**ADDENDUM #1
TO THE
SPECIFICATIONS AND CONTRACT DOCUMENTS
FOR**

**Camas Library Building Improvements
City Project No. FAC23007**

October 14, 2024

A221

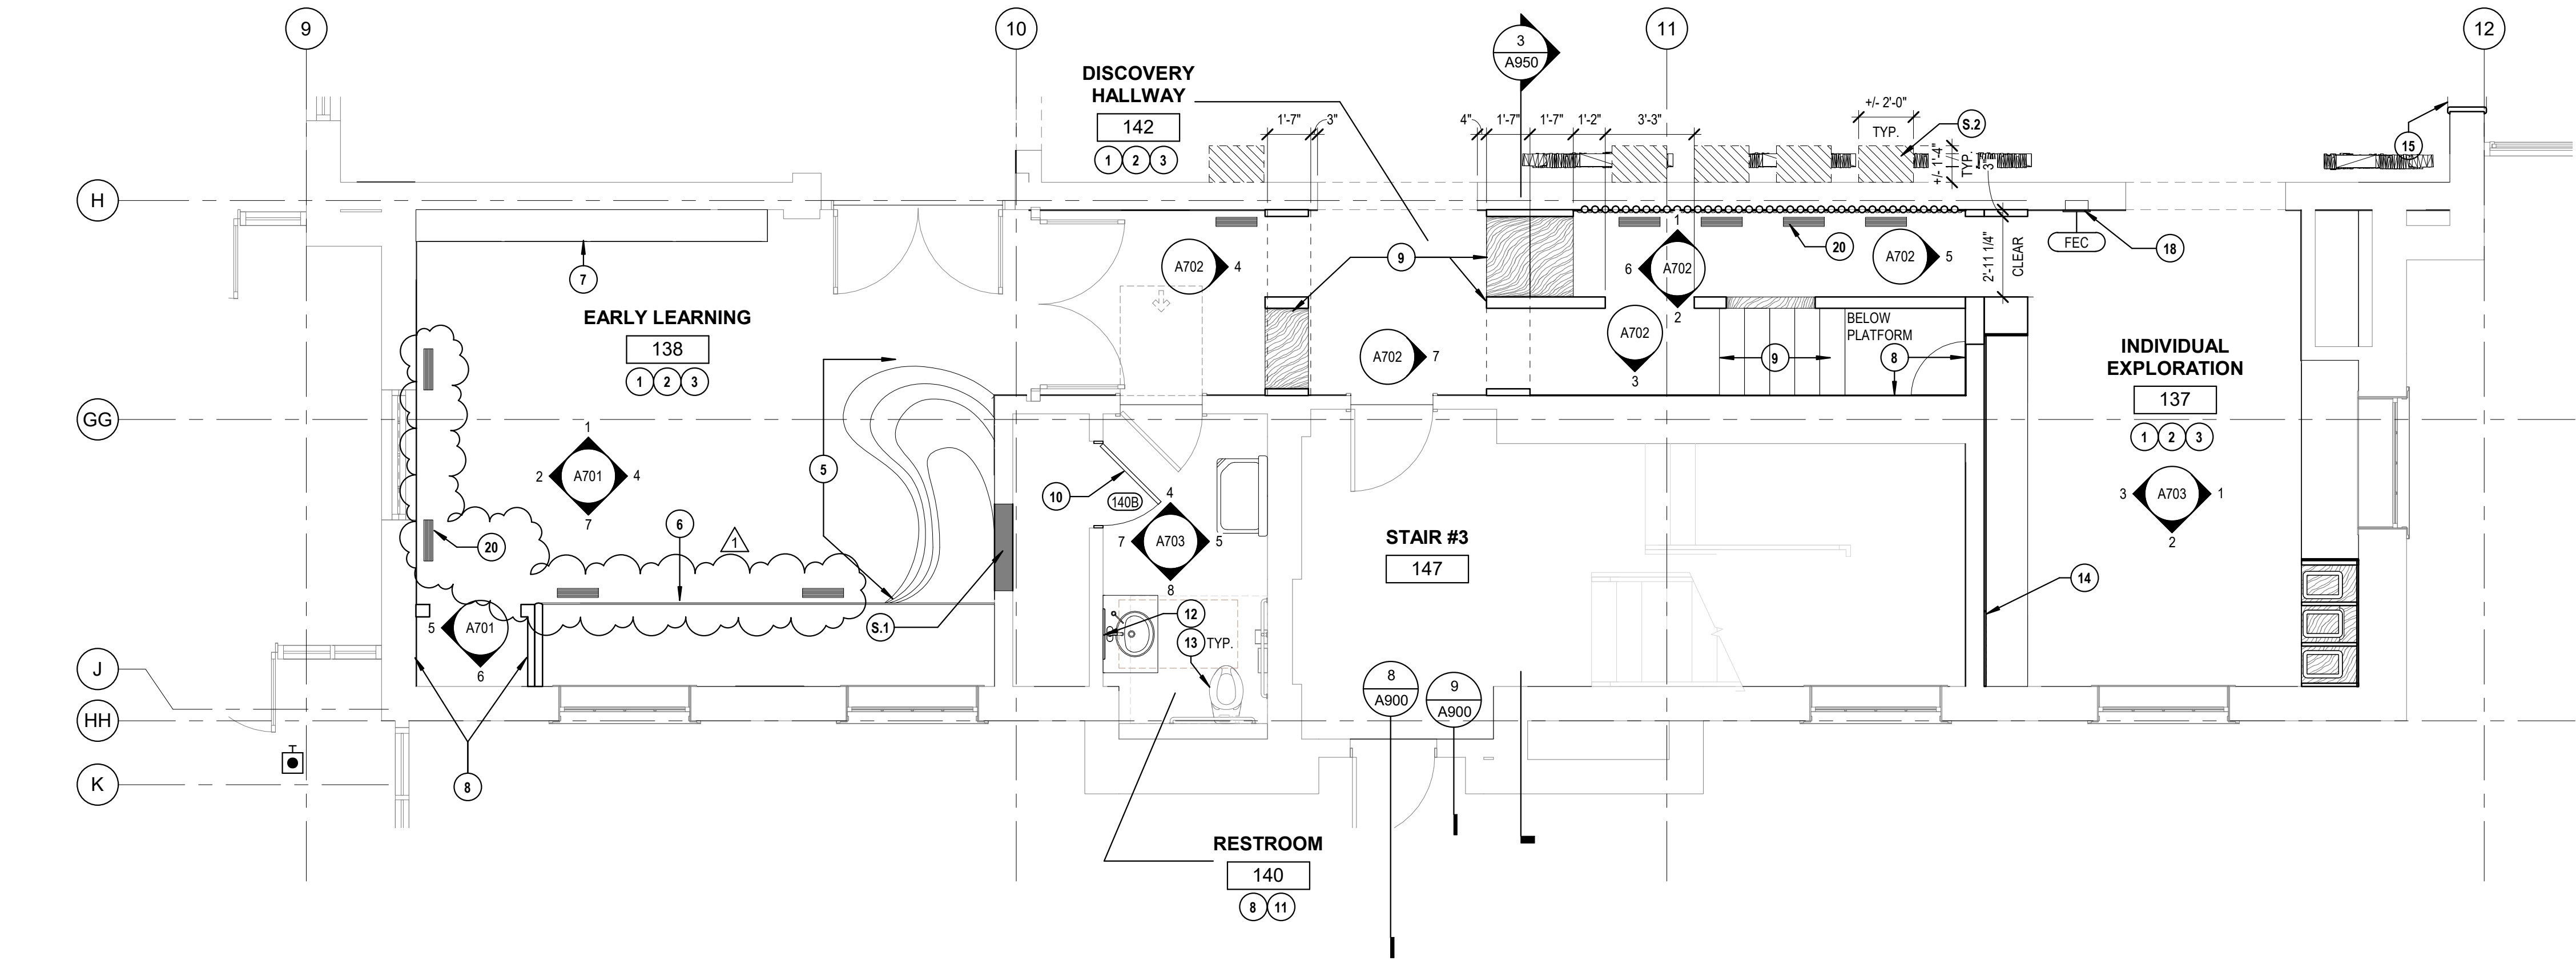
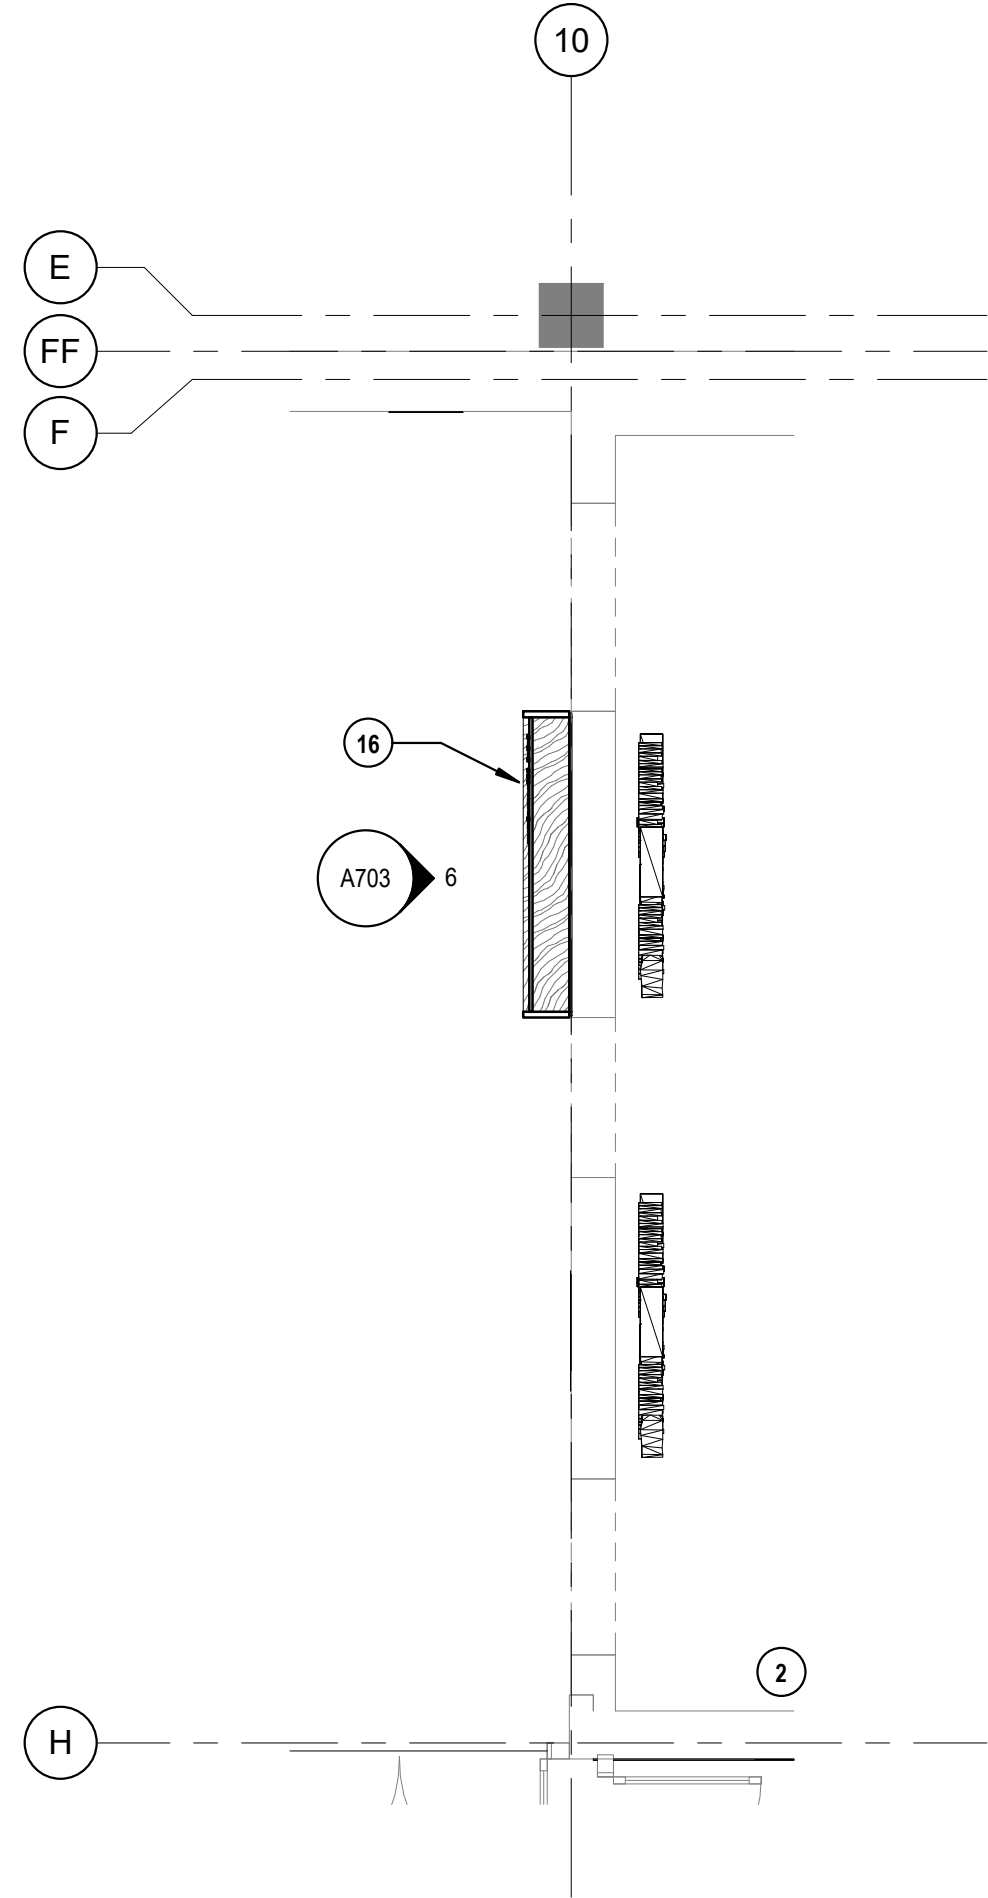
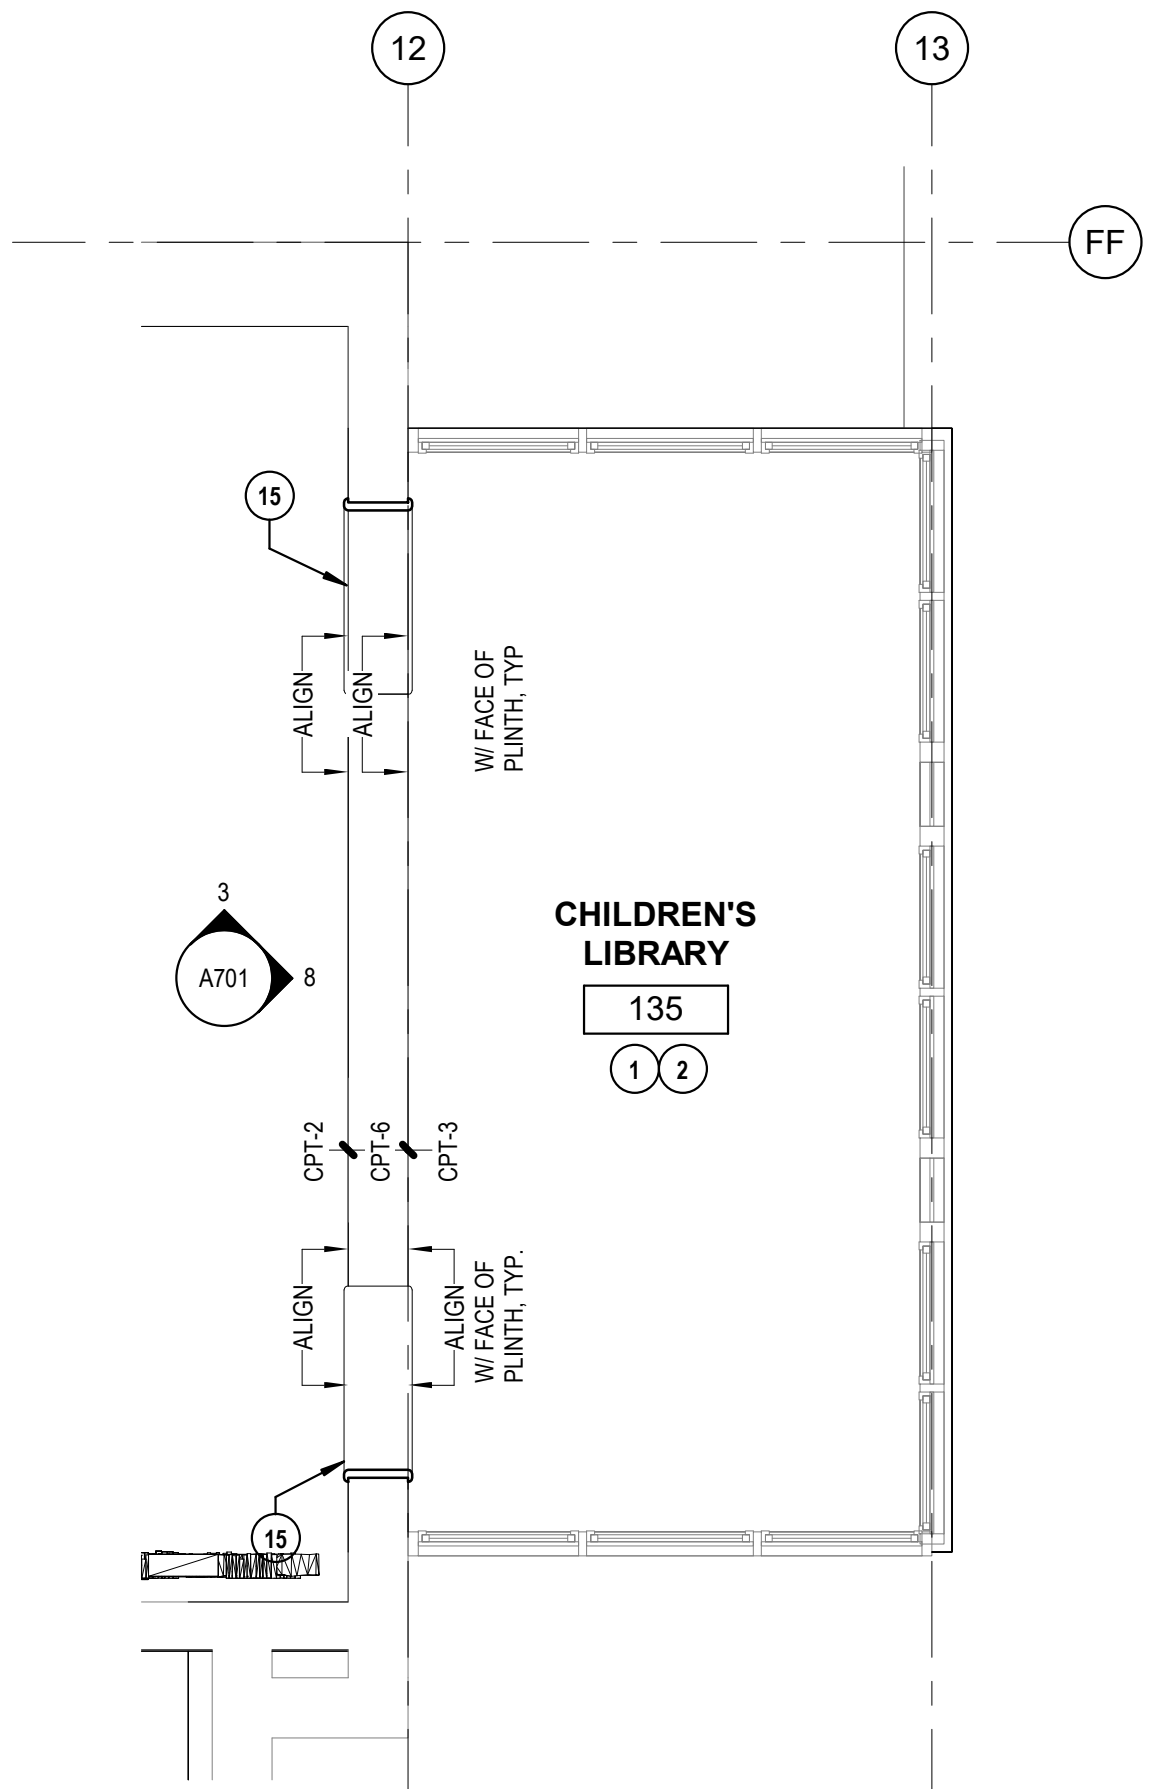
Replace sheets A221 and A303 in their entirety with the attached addendum #1 sheets A221 and A303.
